BOARD ACTION REPORT - APPEALABLE ITEM

Project Name: 219 SE 7th AVENUE Project Location: 219 SE 7th AVENUE

Request: Waiver, Certificate of Appropriateness & Site Plan and Landscape Plan

ITEM: 219 SE 7th Avenue, Marina Historic District-Certificate of Appropriateness,

SITE PLAN

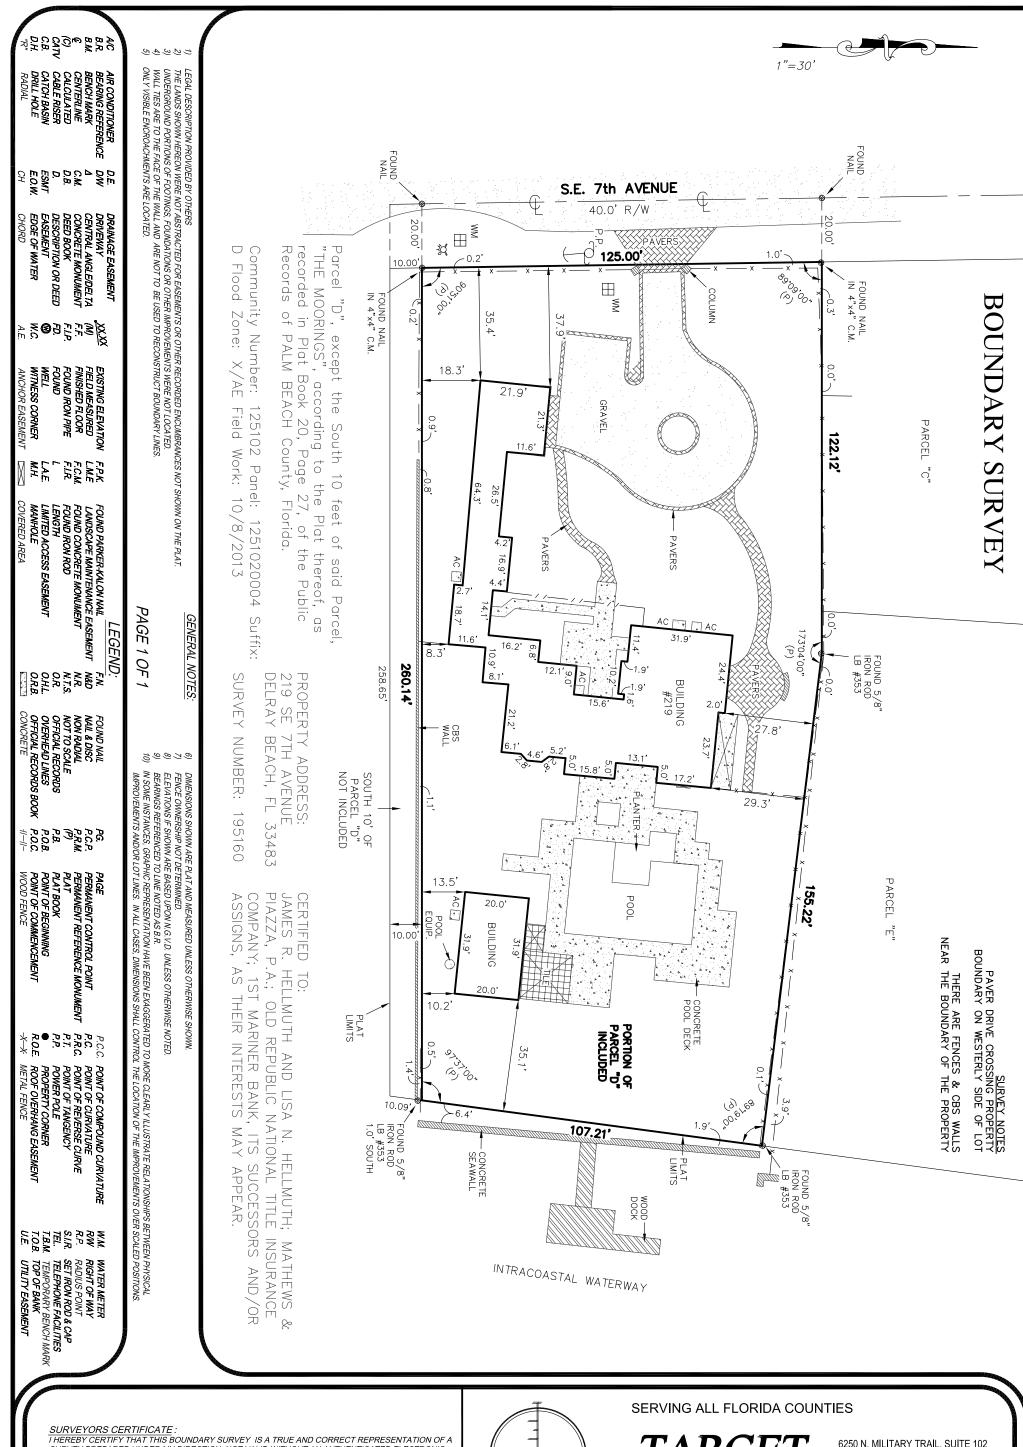
REVISED 4.14.17: AS PER HPB COMMENTS:

2. REVISED FRONT GATE &
COLUMNS. 3. ADDED DRIVEWAYS OF

elevation plan

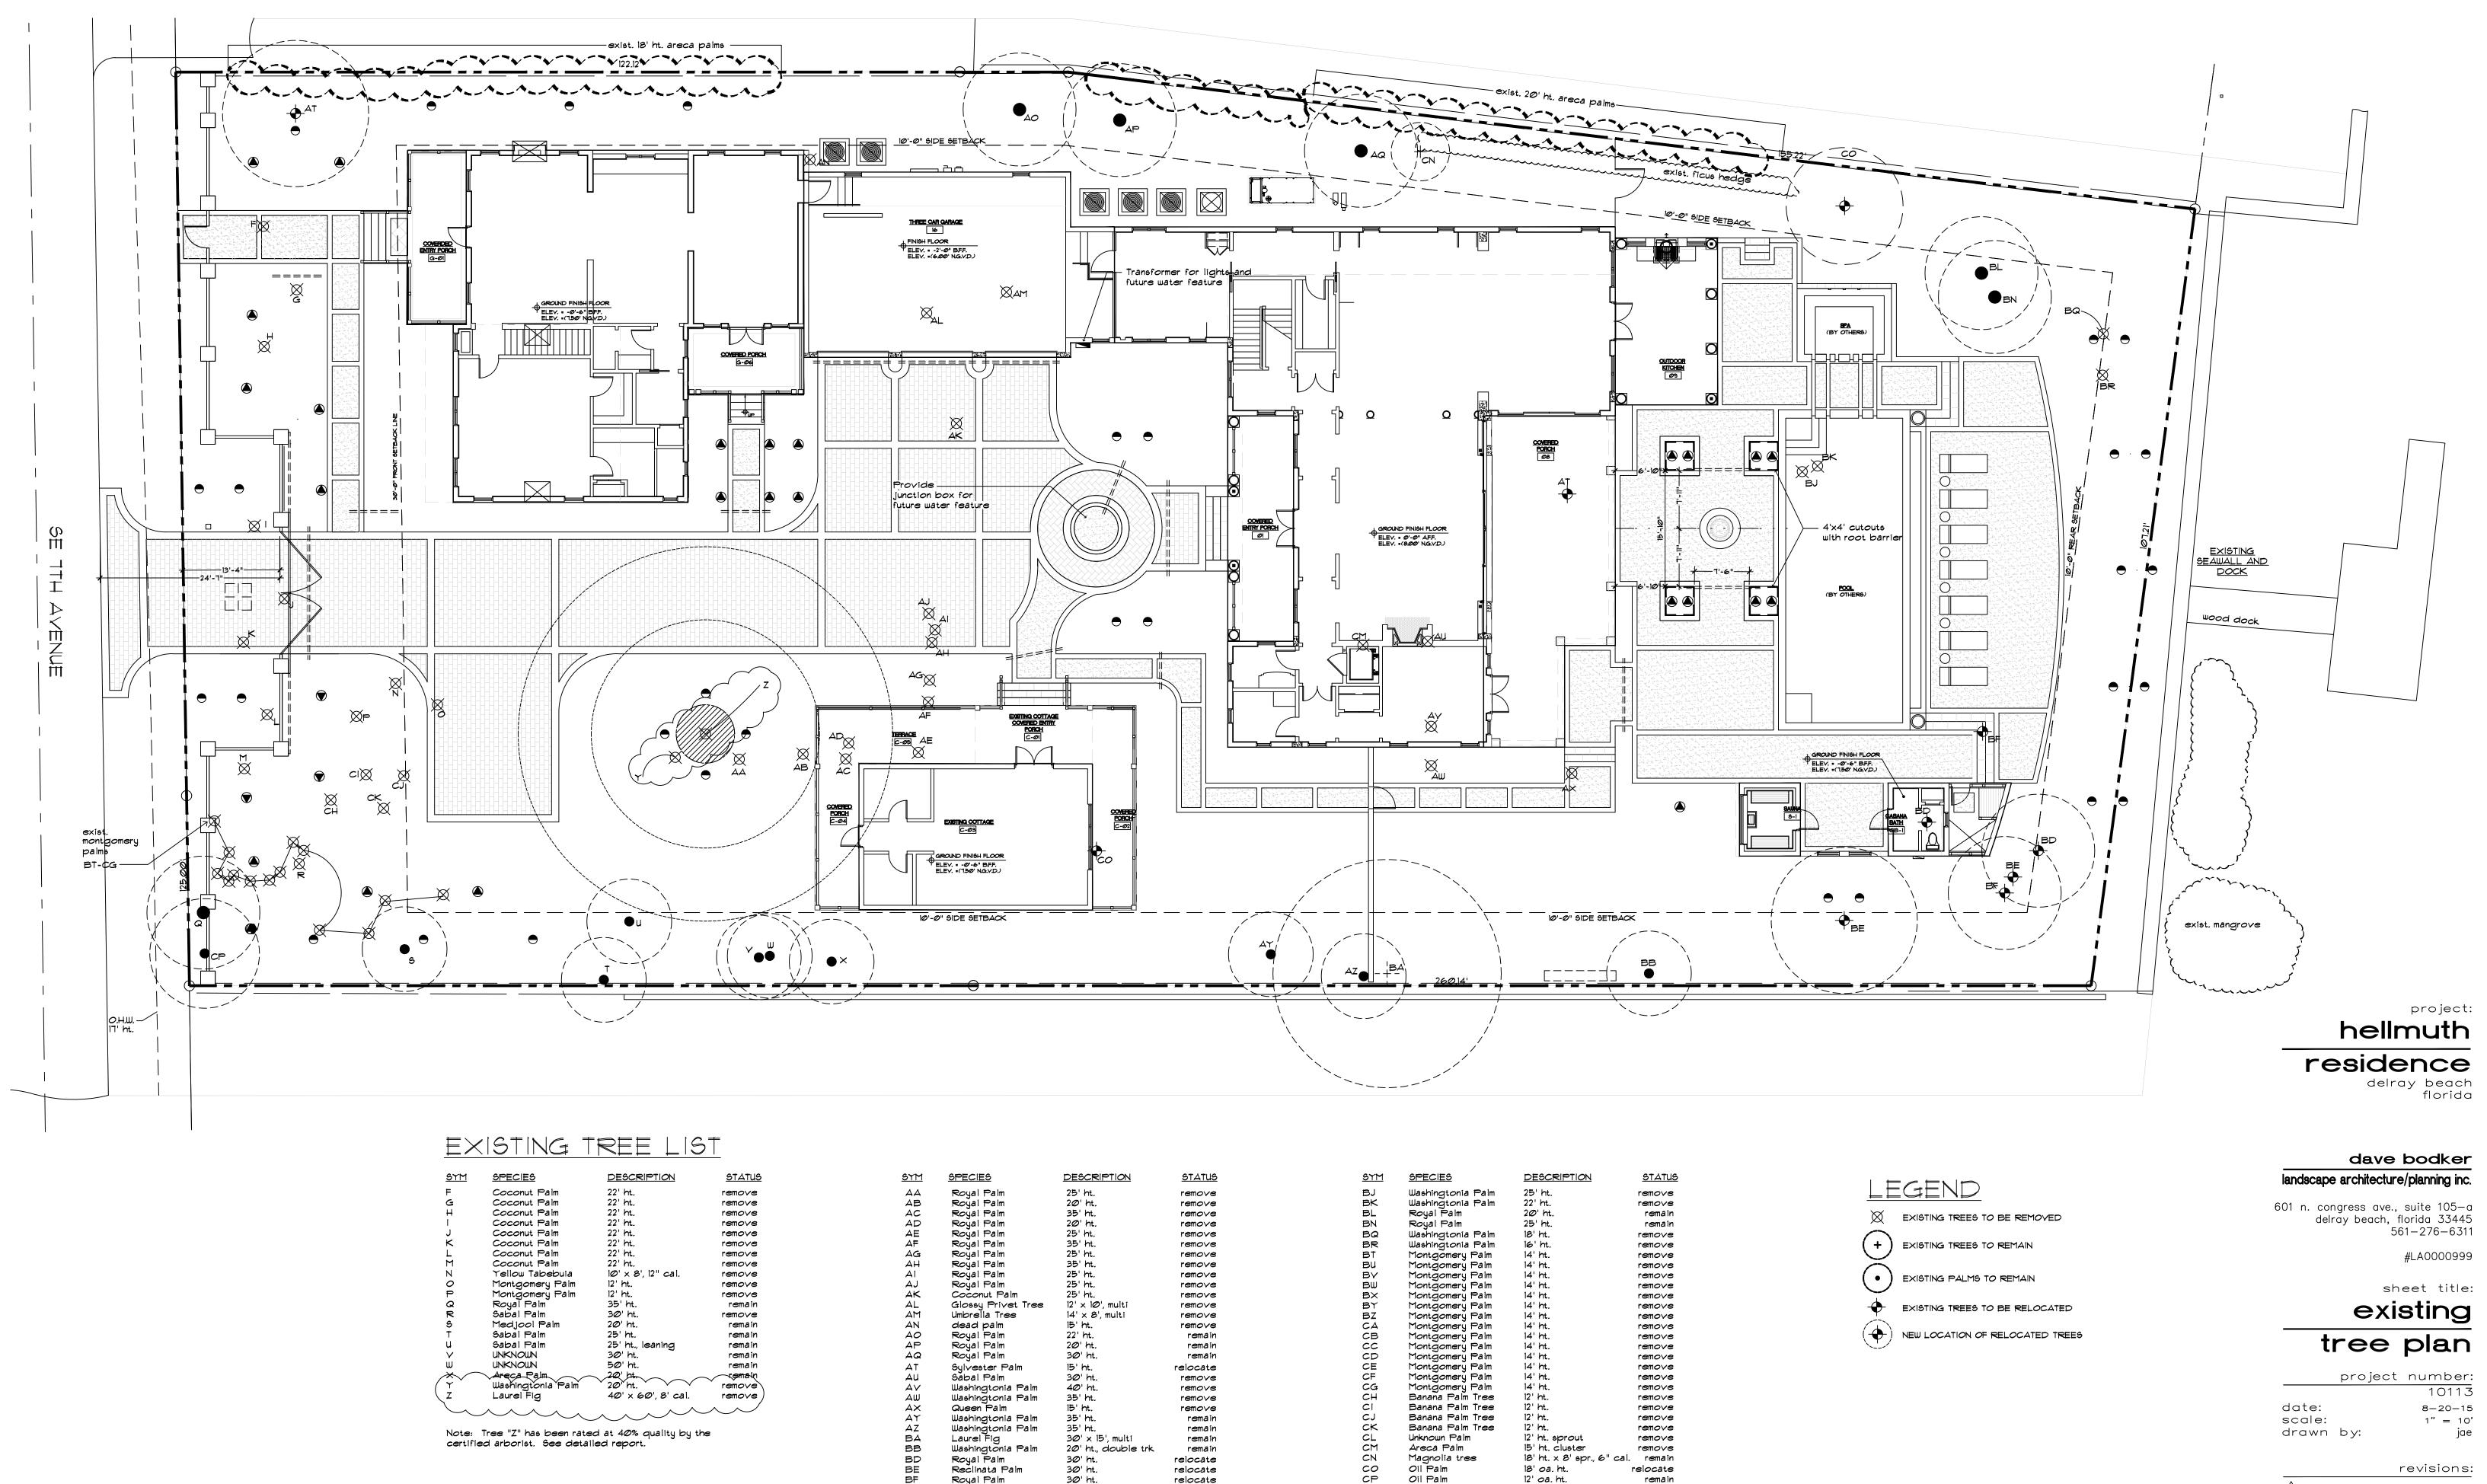
requested the pedestrian gate to be 5'2" high for security purposes. The Board agreed and included this in the conditions of approval.

1. That the proposed aluminum picket fence and pedestrian gate do not exceed 4' in height and the notations on the plans be revised accordingly prior to certification of the Site Plan.
